UNITED STATES  
DEPARTMENT OF THE INTERIOR  
BUREAU OF LAND MANAGEMENTFORM APPROVED  
OMB NO. 1004-0135  
Expires: July 31, 2010**SUNDRY NOTICES AND REPORTS ON WELLS**  
*Do not use this form for proposals to drill or to re-enter an abandoned well. Use form 3160-3 (APD) for such proposals.***SUBMIT IN TRIPLICATE - Other instructions on reverse side.**

BOPCO, L.P., respectfully requests permission to make changes to our 8 point drilling program of the above captioned well to include pressure control equipment information.

BOPCO, L.P.  
PLU Pierce Canyon 4-25-30 1H  
T25S-R30E, Sec 04  
June 7, 2013

**13-5/8" X 3-M BOPE (2 Rams and Rotating Head) &  
Closed Loop System Equipment Schematic  
Diagram A**

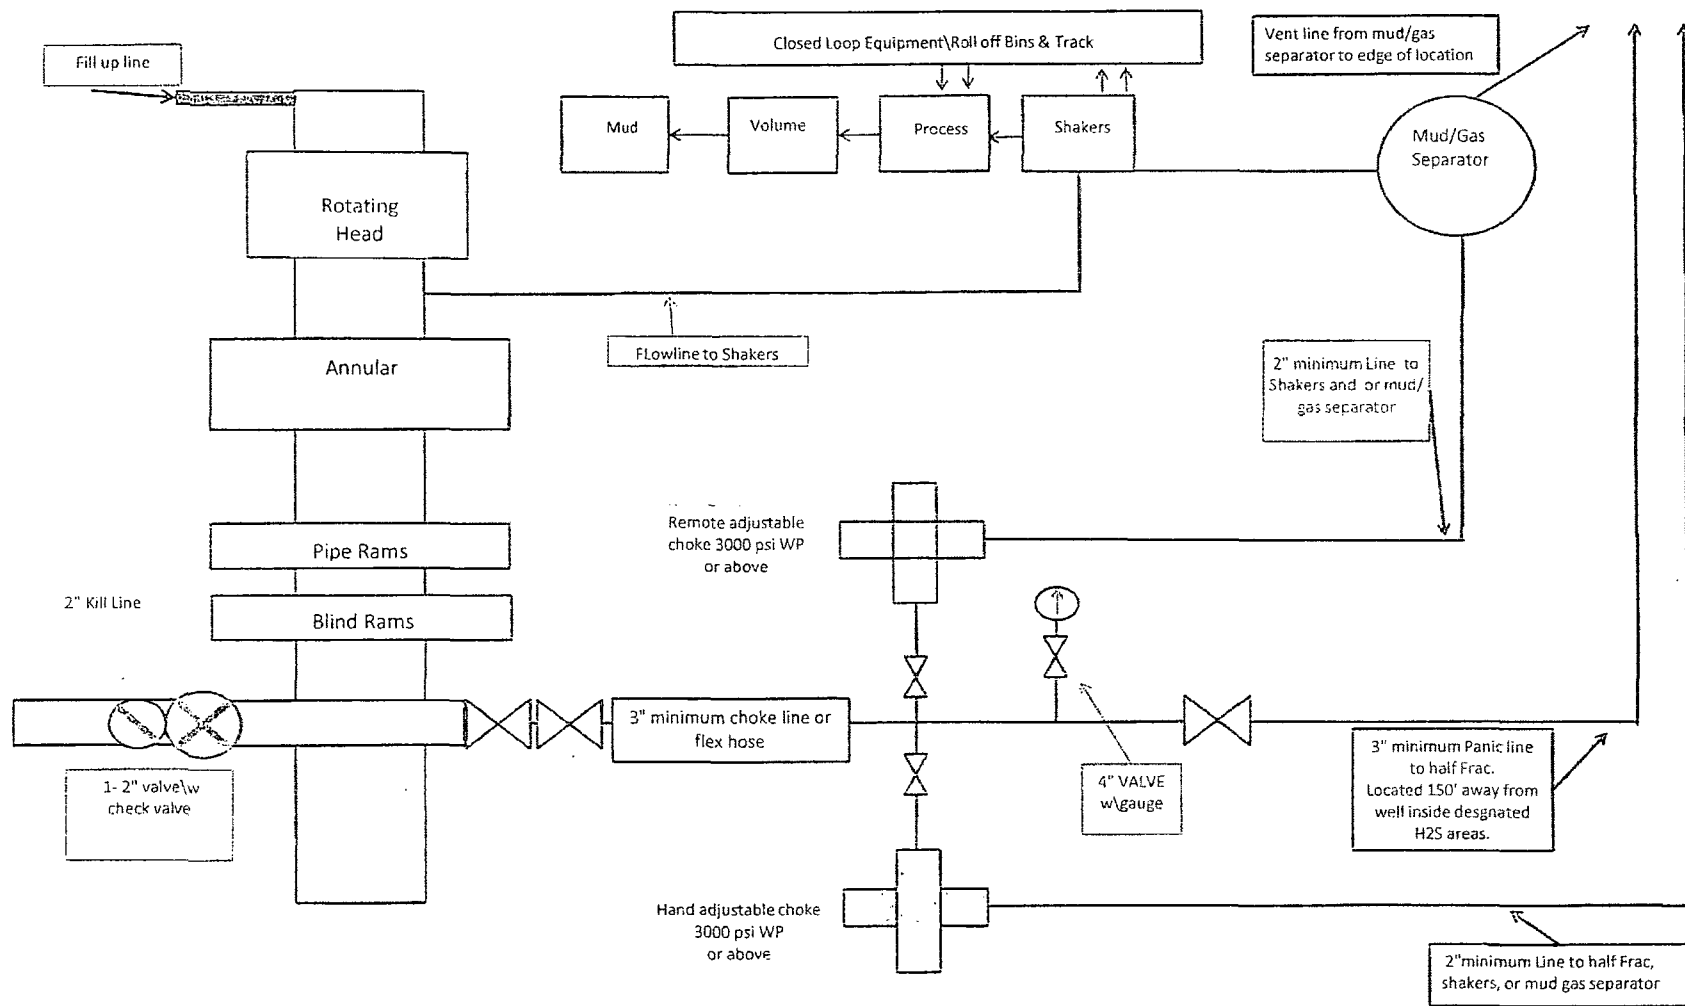
Point 4: Pressure Control Equipment (See Attached Diagrams A, B or C)

After running the 13 3/8" surface casing, a 13 3/8" BOP/BOPE system with a minimum rating of 3M will be installed, used, maintained and tested as per Onshore Order #2. In addition to the high pressure test, a low pressure (250-300 psig) test will be performed.

After running the 8 5/8" intermediate casing, a 13 5/8" BOP/BOPE system with a minimum rating of 3M will be installed on the 8 5/8" intermediate casing spool (7 7/8" open hole), used, maintained and tested as per Onshore Order #2. In addition to the high pressure test, a low pressure (250-300 psig) test will be performed.
